7 March 2024

RE: **RESPONSE TO INFORMATION REQUEST**
****SECTION 13.2 OF THE DEVELOPMENT ASSESSMENT RULES****
****62-84 & 86-108 TALINGA DRIVE, PARK RIDGE QLD 4125****

Response to Information Request

Figure 1 – Extract of Figure 2.3.3.1 of the Planning scheme policy 8 - Urban Design : Example of diverse mix of frontage sizes in the Low density residential zone

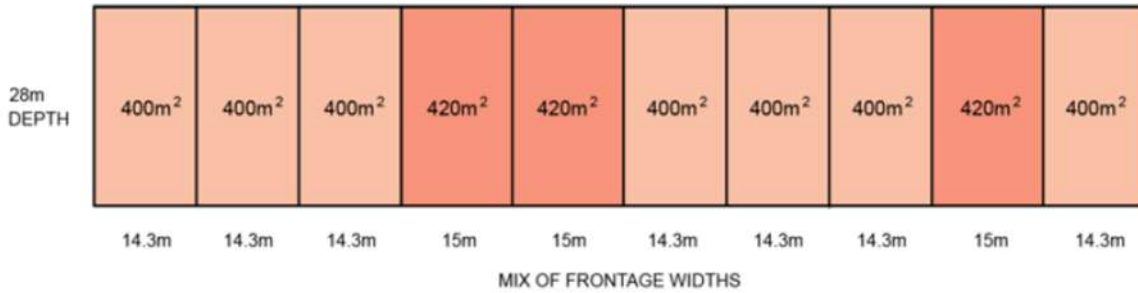
1.1 Provide an amended Subdivision Concept plan which illustrates a minimum frontage width of 14 metres for Lots 29, 37, 47 and 55.

The increased frontage width for the above lots will provide an identifiable difference in the lot frontages when compared to adjoining lots with proposed frontage widths of 12.5. The amended frontages will avoid concentrations of similar sized lots while adding to the overall lot diversity of the development.

As requested by Council, the lot frontages have been adjusted within the Central block to ensure a greater variety of lot widths are provided, where possible. In particular, there are no more than 3 lots in a row with the same size and frontage, lots 30 and 54 have been increased to 14m in width and Lots 36 and 48 have been increased to 13.2m in width to provide more of an identifiable difference in frontages. Refer to the revised plans in **Appendix A**. While the width of Lot 36 and 48 (13.2m) are only 0.7m different than the surrounding 12.5m wide lots, we note that this variation in lot widths (+/- 0.7m) is consistent with Figure 2.3.3.1 of the Planning scheme policy 8 - Urban Design (being examples of diverse mix of frontage sizes in the Low density residential zone), which shows 14.3m wide lots being broken up by 15.0m wide lots (difference of 0.7m) - refer to **Figure 1** below.

Figure 2 – Concept Plan in relation to the Park Ridge LUAP

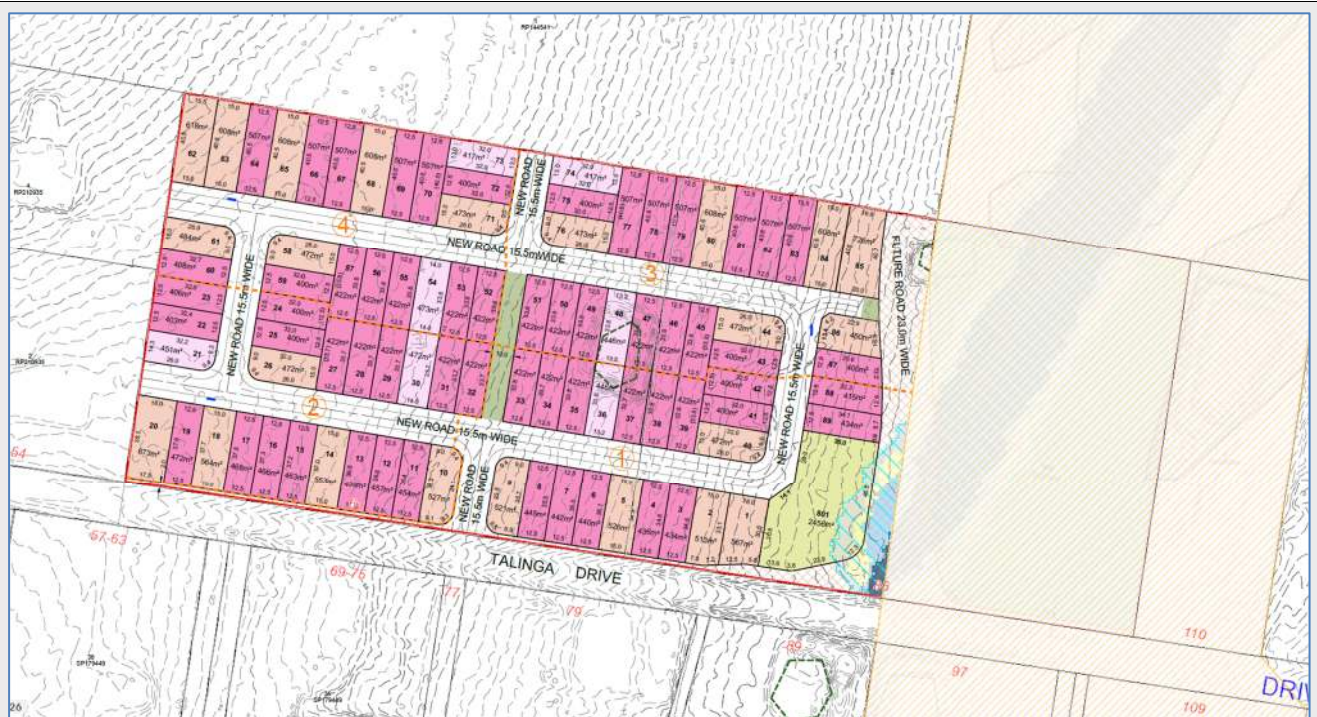
1.3 Provide a Site Plan of the proposed development which includes an overlay of the site’s designation under the Park Ridge Land Use Area Plan (LUAP). The plan will be used to identify which components of the development fall within the Low density residential designation and those which are located in the Environmental management area designation.

Figure 2 below shows the proposed Concept Plan in relation to the Park Ridge Land Use Area Plan (LUAP), although it is important to note that plan is not particularly accurate given the North-South Collector Road is shown as 100m wide on the Park Ridge LUAP (when it only needs to be 23m wide as per Council’s standards). However, it is clear that the land to the East of Compal Road is intended to be within the environmental management area while the land to the West of Compal Road is intended to be within the low density residential zone. Given the future alignment/design of Compal Road has been locked in and has been provided generally as per Council’s preliminary road design, no development will be located within the environmental management area. Similarly, as illustrated in **Figure 3** below, no development is proposed within the mapped Biodiversity Corridor, other than some of the future trunk road, which is required to be located within this corridor – as this is where it has been designed by Council.

Figure 4 – Proposed plans in relation to the Precinct Plan for COM/10/2022

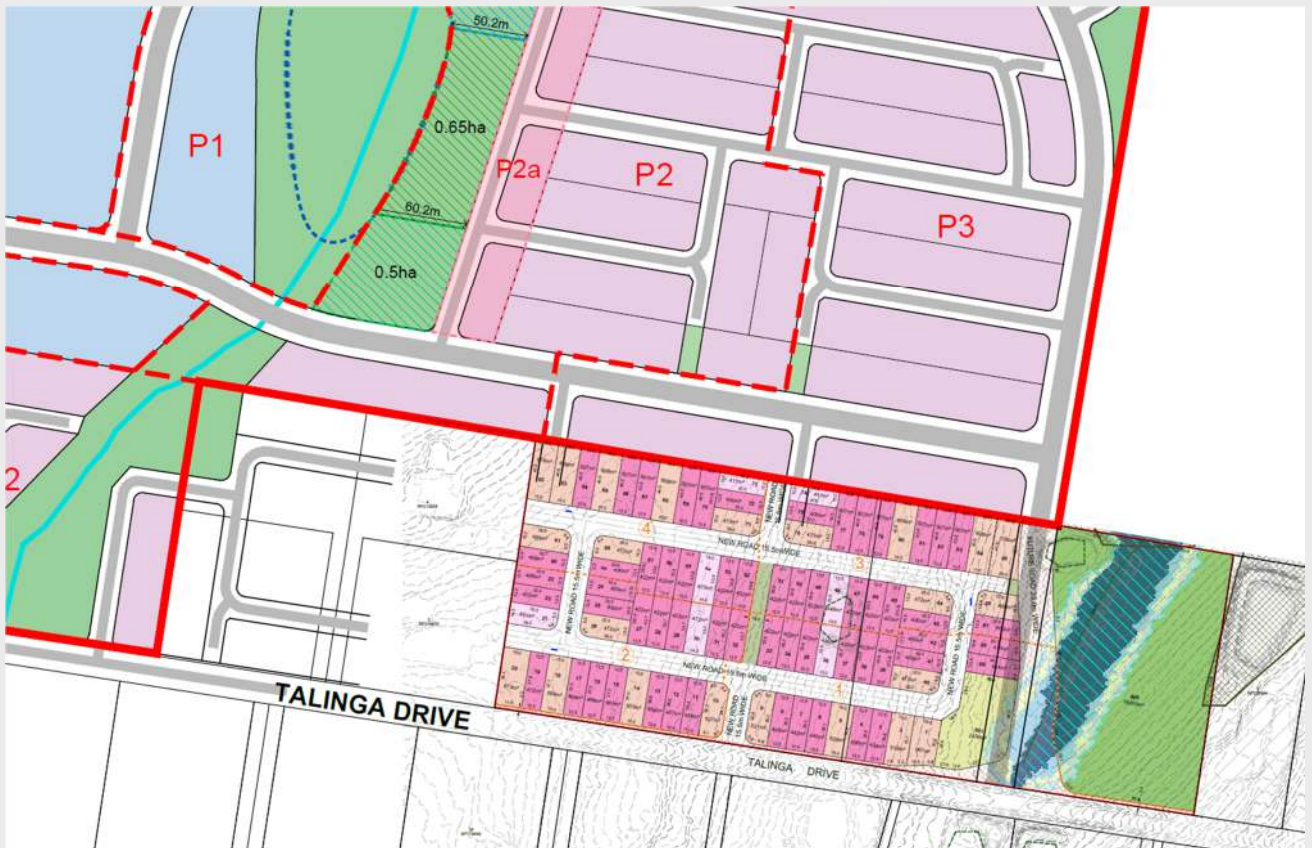
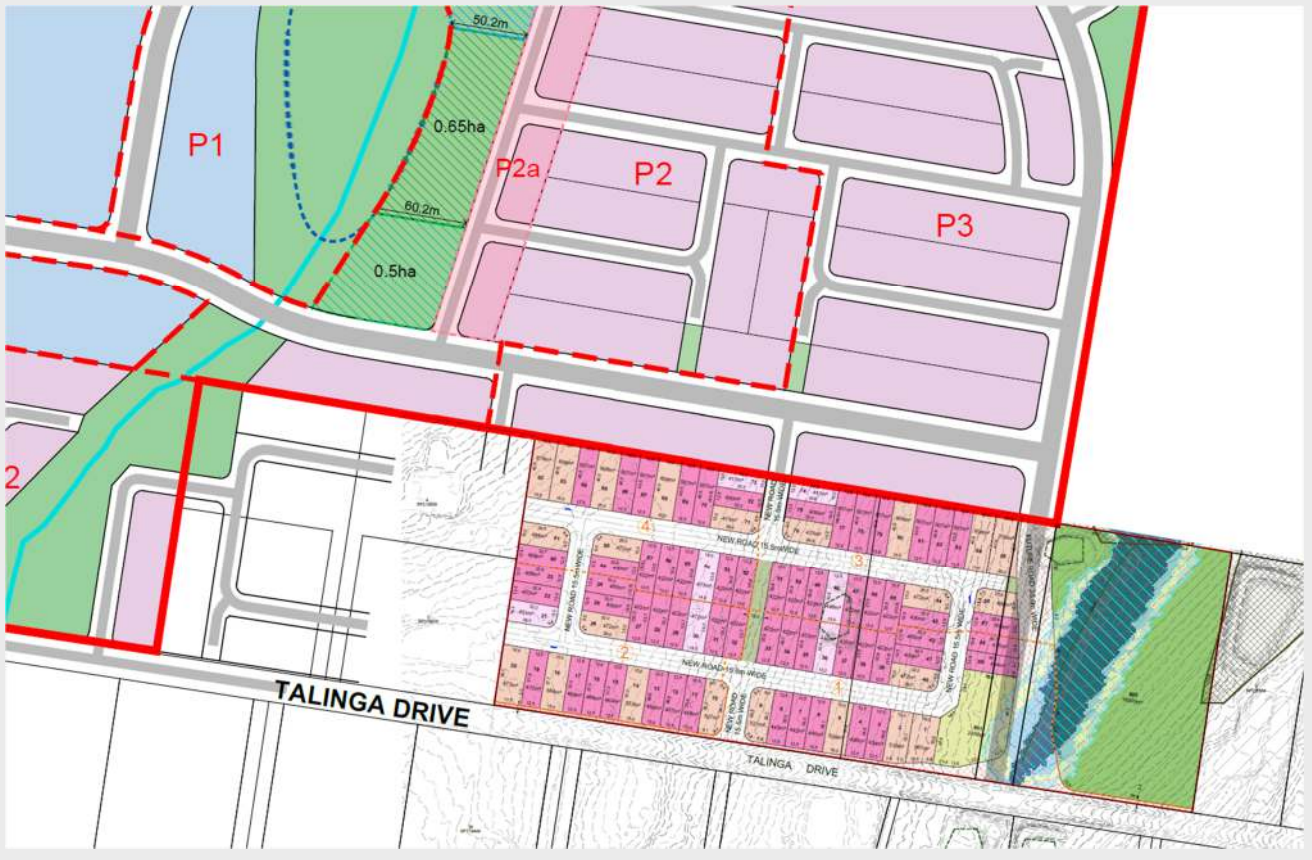
3.2. Amend the plans of development to include the second connection to the north as shown on the COM/10/2022 proposed structure plan (see Figure 1: Excerpt from COM/10/2022 structure plan below), ensuring that both connections align with the future road network proposed by COM/10/2022.

Refer to the response from TTM in **Appendix D** and the response from Arcadis in **Appendix C**. In relation to Item 3.2, it is acknowledged that the proposed Northern road connection does not exactly align with the indicative future Southern road connection/s shown on the proposed Precinct Plan prepared by Urbis for the adjoining development application to the North (Council Reference: COM/10/2022) – refer to **Figure 4** below. However, it is important to note the following:

- The adjoining development application is for Preliminary Approval only to vary the effect of the Logan Planning Scheme 2015. The Precinct Plan prepared by the applicant is a high-level strategic planning document which was prepared to demonstrate to Council how the subject site could be developed in future and how future road connections could be provided to facilitate the orderly development of the adjoining land (including 62 – 108 Talinga Drive);

- The exact design and location of future roads within the land associated with COM/10/2022 (including future road connections to the adjoining land) will be formalised/refined as part of subsequent Reconfiguration of a Lot applications and it's highly likely that the location of the proposed roads will differ slightly from those shown on the Precinct Plan as the development becomes more refined.

- As per the indicative Precinct Plan, the two Southern road connections that are currently shown on the Precinct Plan are to be delivered as part of Precinct 3 which is a "future residential precinct" and likely to be one of the final stages of the adjoining residential development. Therefore, this application will be decided well before any detailed planning/road design has been undertaken for a future ROL application involving Precinct 3;

- COM/10/2022 has not yet been approved by Council and is still being assessed – therefore it may be subject to change. However, even if COM/10/2022 is approved and Precinct Plan forms part of this approval, the proposed development is not considered to be inconsistent with the overall road network strategy identified in this Precinct Plan. The two current blocks shown on the Precinct Plan (formed by Compal Road and the two Southern road connections) are ~140m wide. These grids could easily be made slightly longer and the subsequent road network adjusted accordingly and still achieve an outcome that is almost identical to the current Precinct Plan (refer to **Figure 5** below), and providing a functional grid pattern. **Figure 5** below illustrates that an additional Northern road connection could easily be provided as part of the future development of the adjoining land to the West.

Overall, the proposed Northern road connections are considered adequate given the circumstances and the location of these doesn't conflict with the future planning for the adjoining site to the North.
